Integrated Circuit Design for High-Speed Frequency Synthesis

John W.M. Rogers, Calvin Plett, Foster F. Dai

This book is now available, as of February 2006, and as expected, some errors are being found. If you find errors in this book, or have comments about this book, please send email to cp {at} doe {dot} carleton {dot} ca. A list of errors, comments, etc will be posted. If you would rather not be acknowledged on the errata list, let us know and your name will not appear. [Comments in blue have been added since the last version of the errata updated on March 10, 2007.](#)

Page 90, Figure 4.3. The input to the flip-flop labeled as \bar{R} should actually be clock. Also, the bottom two nand gates should not both have outputs labeled with R, The top of these should be \bar{R} . The correct diagram is given below. (mm)

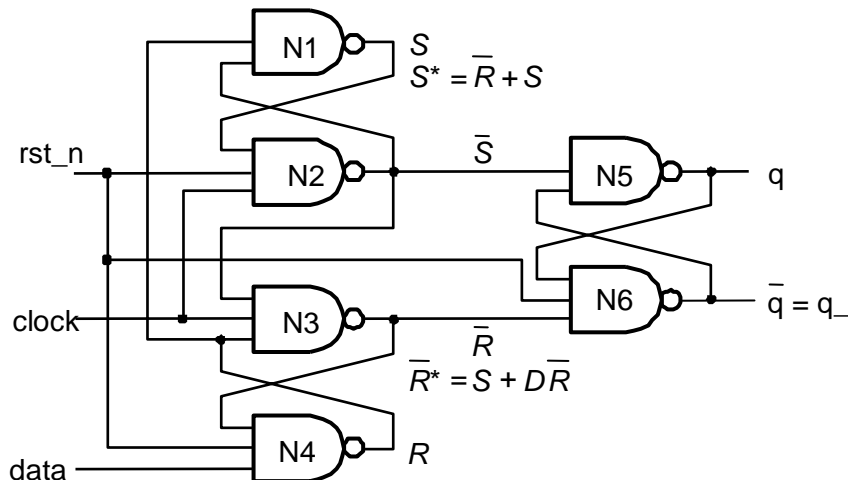
Page 90 Diagram for flip flop should have “clock” instead of “Rbar” as input. (mm)

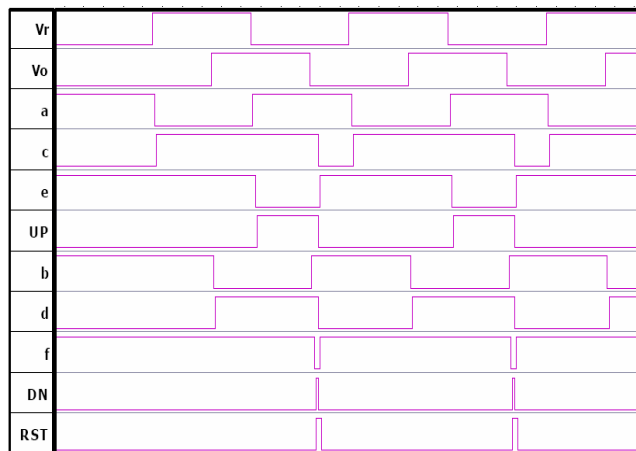
Page 191, 192, At the top left of the modified tri-state PFD is a nand gate with v_R as an input and a as the output. Whenever an input to a nand gate is low, the output must be high, yet in the plots on page 192, sometimes v_R and a are both low. Similarly, in the bottom gate, when v_o is low, b must be high, but again the plot shows times when both are low. The schematic is correct, but the output plots are in error. The correct output plot should be as shown below.
